PZC -23-012
Date 5/3/2023

PROJECT NAME Hampton Village

HOUSING OPPORTUNITY DEVELOPMENT SUBDIVISION HAMPTON VILLAGE

37 SOUTH MAIN STREET EAST HAMPTON, CONNECTICUT

E & S CONTROL PLAN

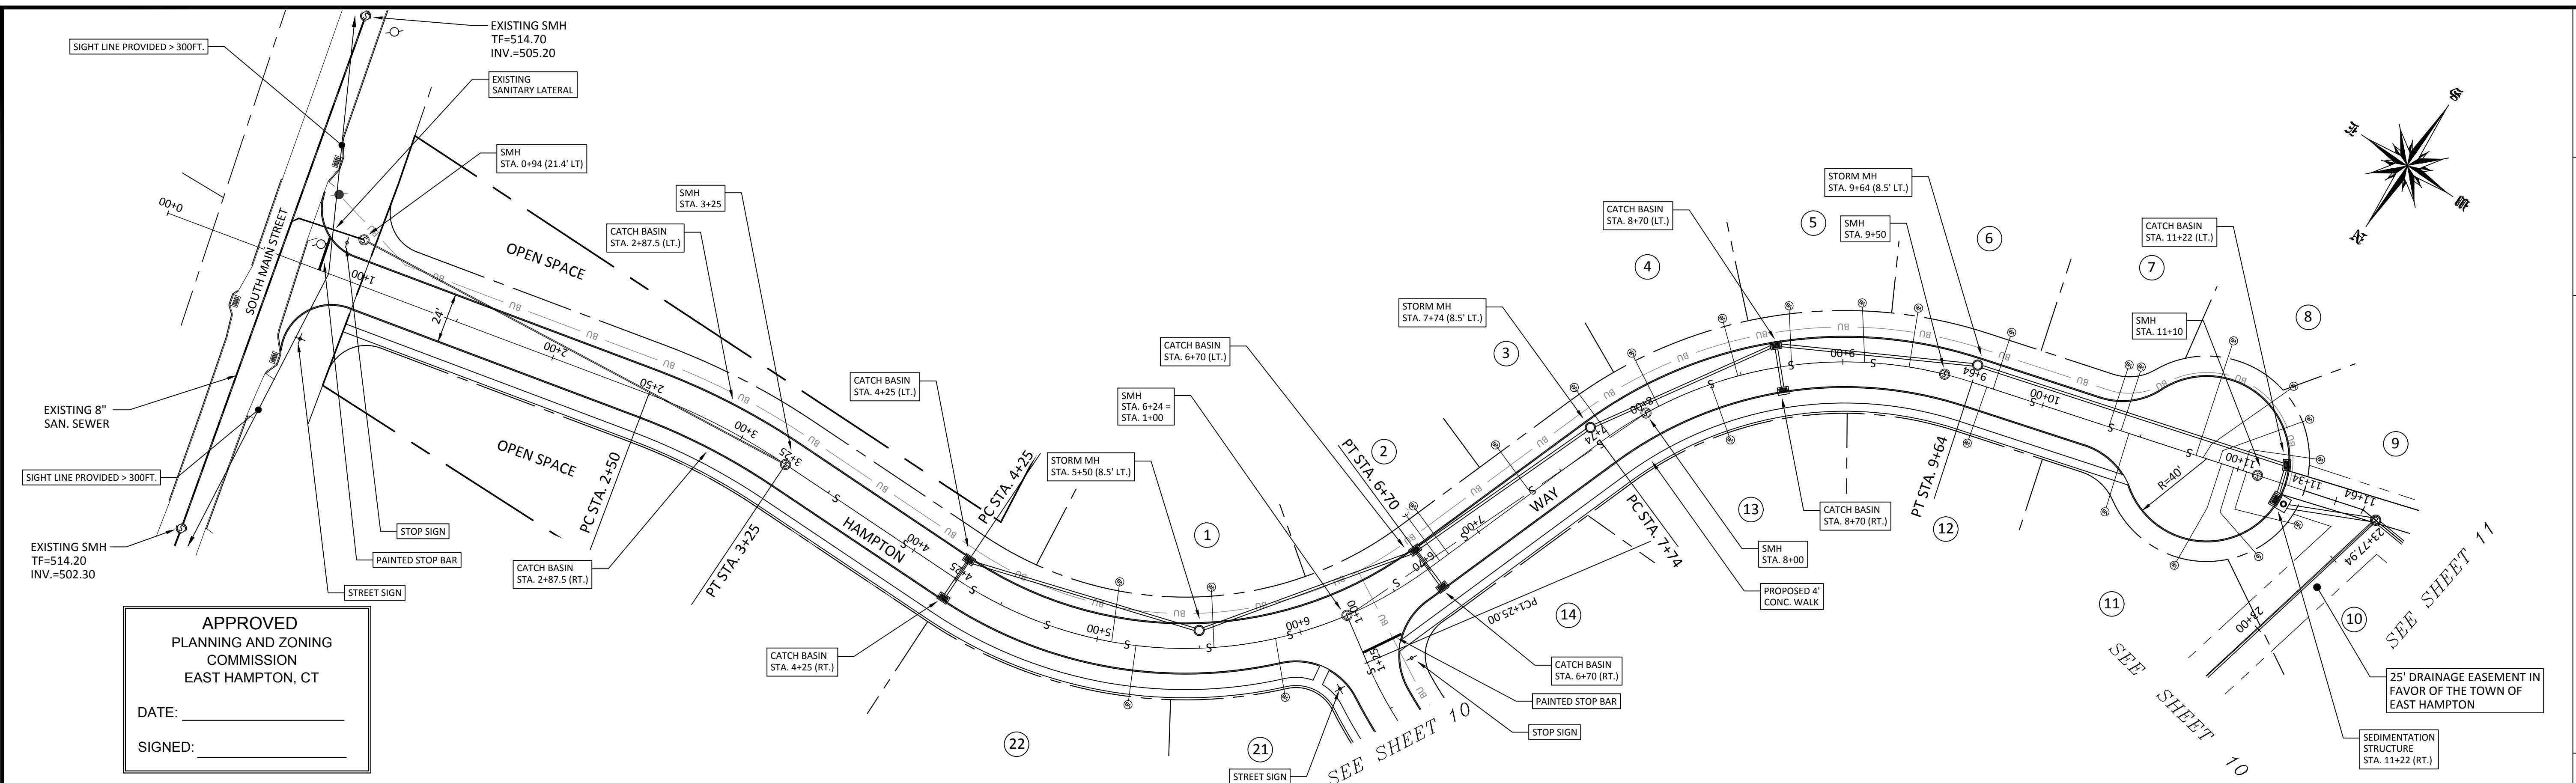
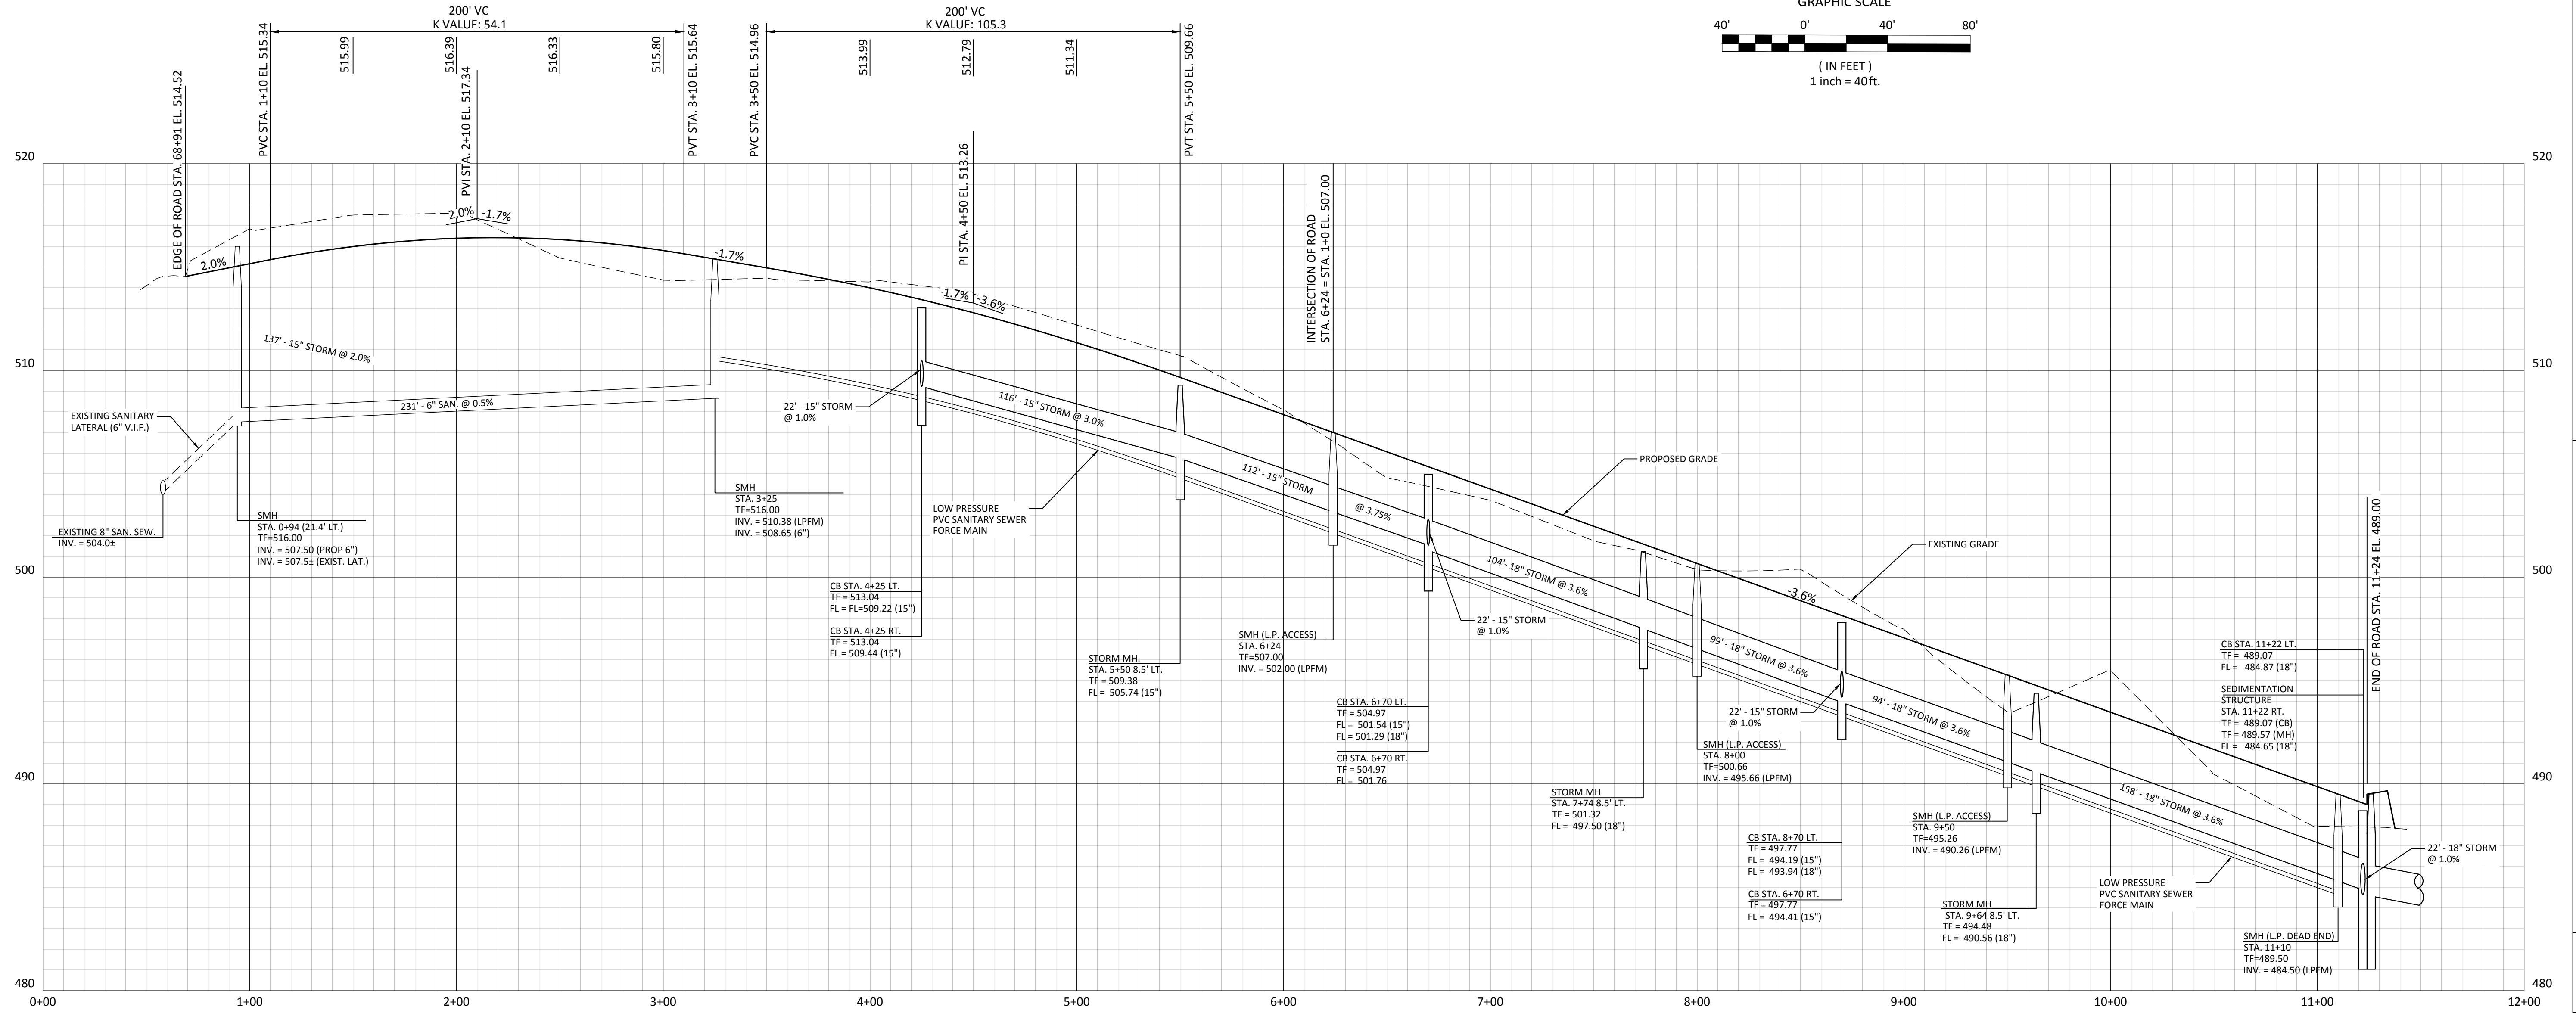
1. Erosion control fencing needs to be included down-gradient of the area where the stormwater pipe will be installed between the two cul-de-sacs.
2. A temporary soil stockpile is shown on sheet 8 as being outside the limits of clearing. Please either change the limits of clearing, or relocate the stockpile area.

5. Sheet 12 includes a detail for stone barriers, however, no stone barriers appear on the plan.
6. On Sheet 8, the bottom elevation of the stormwater basin is shown to be 443. However, on sheet 11, the profile indicates the bottom of the basin lies at elevation 465. This discrepancy is throughout, including top of berm, etc. Drainage manholes include a similar discrepancy between pages 8 and 11. Please rectify.
